Mitchell Shire Planning Scheme Amendment C106

Urban Design & Landscape Evidence
prepared by Craig Czarny, Hansen Partnership

July 2020

3 dimensional contour settings are required in order to maintain reading of the Cone in its context -recommended RL326 to building top.

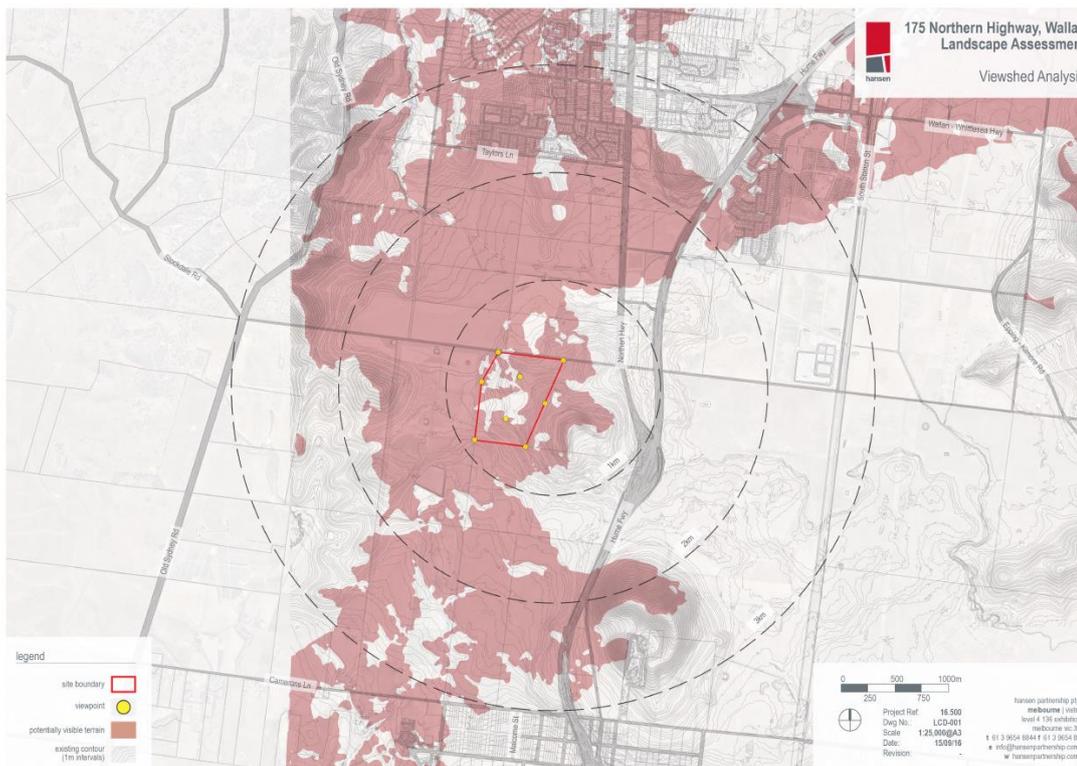
- The extent of the 'Landscape Values' land— particularly around the Spring Hill Cone and adjoining development as set out in the PSP is a critical matter of interest. Some submitters have indicated capacity for housing to rise up beyond the boundary identified in the PSP. While I accept that this needs to be reviewed, it is not appropriate to confine the study to the 'peak' alone. The planning principal of protecting hilltops is not new. Canberra's design (in particular outer growth) was underpinned by retention of foothills and elevated ridgelines. This is manifested in Melbourne's north and south-east (ie Epping and Casey) where hilltops are set aside as public and/or crown managed conservation areas. In each instance, I note that it is **not the hilltop alone (or peak) that is acknowledged, but a landscape context of rising slopes** which permits an appreciation of a broader landscape.

- It is appropriate to identify a contour (RL) on the Cone to limit development encroachment. Submitter 24 supports rising uphill on the south side of the Cone beyond the level of the existing Homestead (RL 333) - **I disagree and believe that development should be contained below (roofline) 326 RL based on modelling and photographic review**. It is essential not to isolate the hilltop— but ensure 'leading slopes' form part of an area of exclusion (as recommended in the 2014 LVA). I note the proposed alignment of a road at the south-west edge of the proposed RCZ within the PSP (rising northward from LP-24 on Plan 7). This is another example of an insensitive topographical approach - where its alignment rises sharply from 329 RL, then turns down a steep incline to the west. Clearly these investigations and infrastructure design should be underpinned with thorough investigative visual impact assessment.

Example Photomontage – Existing V Proposed – View 9 – refer Appendix C for all views

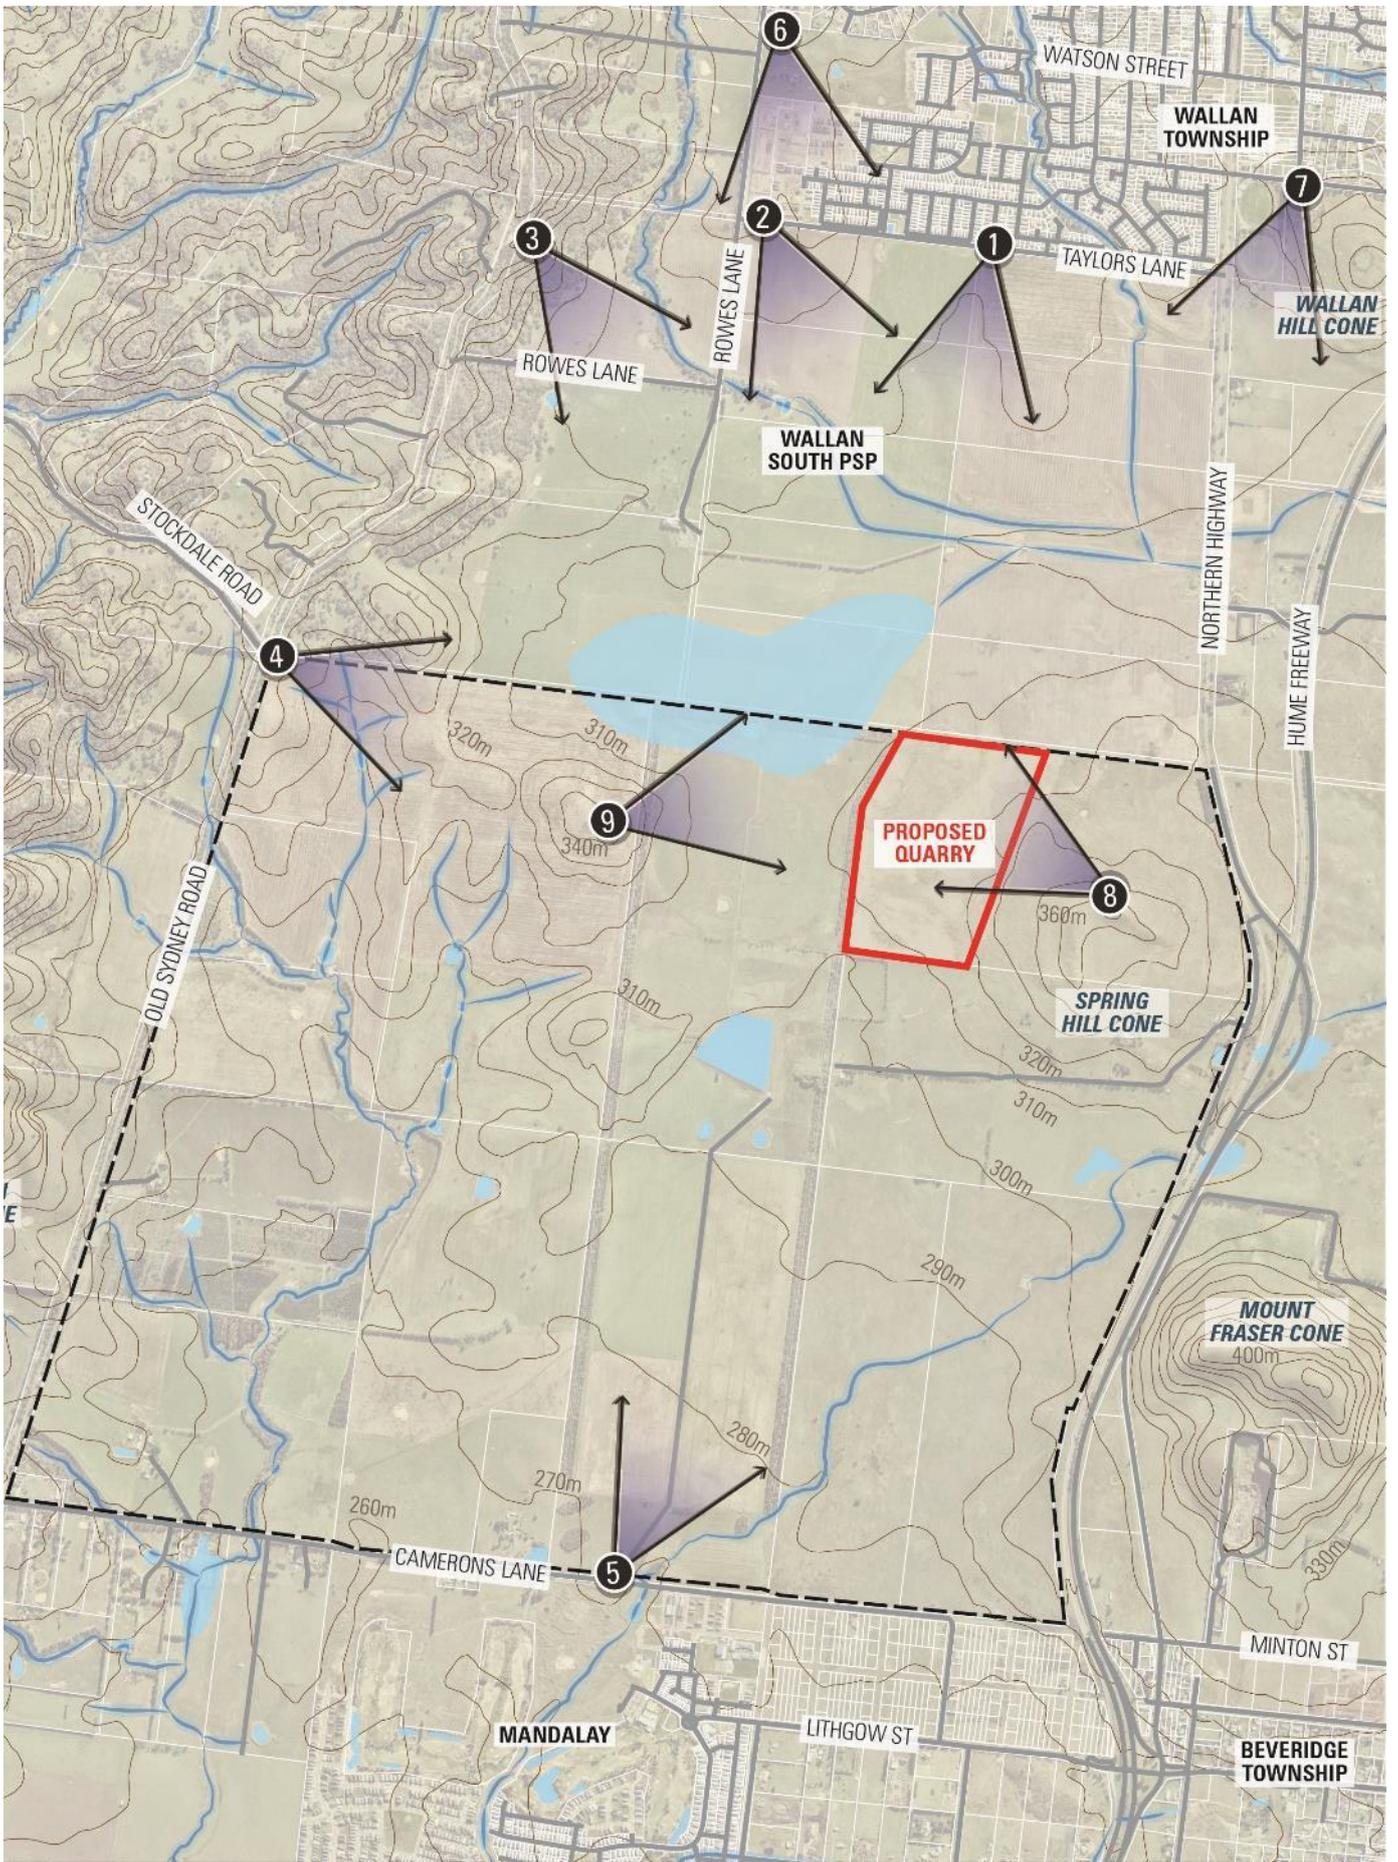
- The viewpoints overleaf and table represents a summary of the visual impact rankings, based on evaluation of photomontages. These illustrate that the proposed quarry will be visible (and therefore cause an impact) at close, medium and long range from within Wallan Township, the emerging Wallan South urban growth areas and at closer range within the Beveridge North-West PSP area – in particular from identified 'key points of interest' (nearby hilltops). While proposed works will not intervene into the skyline or exposed above the outline of the Cone (due to work and operation being typically underneath the existing grade), the **changes to the 'smooth rising' landform and the breadth of proposed works will in my view be dominating, particularly when viewed from within the PSP area at close to medium range.** Mitigation as proposed through buffer planting and earthworks are not in harmony the open smooth pastured landform of the place. Indeed, the significance of the Cone is notable for 'lack of planting'.

- Based on the above evaluation (refer Appendix C for evaluation process and criteria – including ranking levels). I consider the impacts on the landscape values of the setting to be significant, and unable to be mitigated appropriately from key receptor locations (vantage points) within close to medium range. While the proposed works do not interrupt an appreciation of the Cone peaks, it significantly erodes the integrity of the smooth rising slopes across a broad field of vision. I do not believe that it is appropriate to incorporate quarry works of this kind in this urban growth context – in particular where landscape values are so heavily relied upon as a character anchor for the PSP area.
